CRAIG DINGLE	ROOF PLAN			
PROPOSED: ALTERATIONS AND ADDITIONS, FRONT FENCE, DRIVEWAY AND CARSPACE	SCALE: 1:100 SHEET No:			
AND REAR PERGOLA ,TO EXISTING RESIDENCE,  ADDRESS: 48 WOOD STREET DP 241272  MANLY NSW 2095 LOT 1 . SEC 182	DA05			
ICA MAPPINICAH COLINICII	REV: JOB: 06/20

DA2021/0574

PROPOSED: ALTERATIONS AND ADDITIONS, FRONT FENCE, DRIVEWAY AND CARSPACE AND REAR PERGOLA ,TO EXISTING RESIDENCE,					
_	ADDRESS :	48 WOOD STREET MANLY NSW 2095

1:50	SHEET No:
22.09.2020	DA11
JOB: 06/20	1

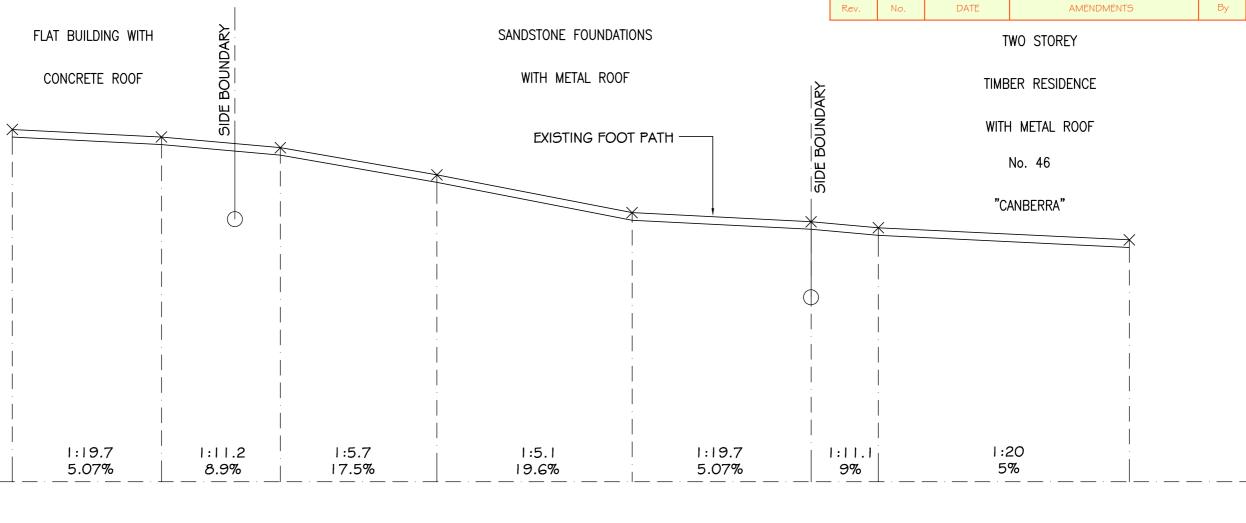
09.03.2021 RL 17 050 REMOVE SIDE HANDRAILS 09.03.2021 NEW PLANTER BOXS AMEND DRIVEWAY No. 48 No. 50 AND FOOTPATH PROFILE 17.12.2020 AS PER TAYLOR CONSULTING TIMBER, BRICK & 17.12.2020 REDUCE WIDTH OF TWO STOREY CARSPACE TO 3500 17.12.2020 REMOVE CARPORT FIBRO RESIDENCE ON BRICK RESIDENTIAL

**STREETSCAPE** SHEET No : **A3 DA13**

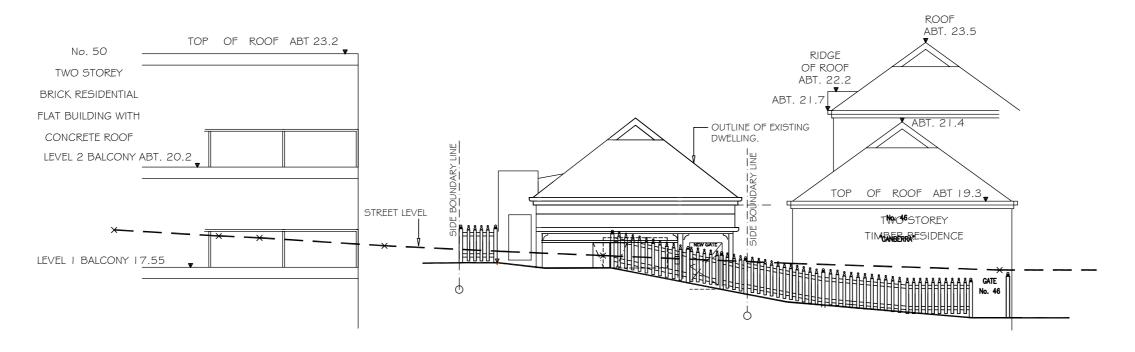
В.	5.	09.03.2021	LOWER REAR CARSPACE RL 17 050	
В.	4.	09.03.2021	REMOVE SIDE HANDRAILS NEW PLANTER BOXS	SF
A.	3.	17.12.2020	AMEND DRIVEWAY AND FOOTPATH PROFILE AS PER TAYLOR CONSULTING	SF
A.	2.	17.12.2020	REDUCE WIDTH OF CARSPACE TO 3500	SF
A.	1.	17.12.2020	REMOVE CARPORT	SF
Rev.	No.	DATE	AMENDMENTS	Ву
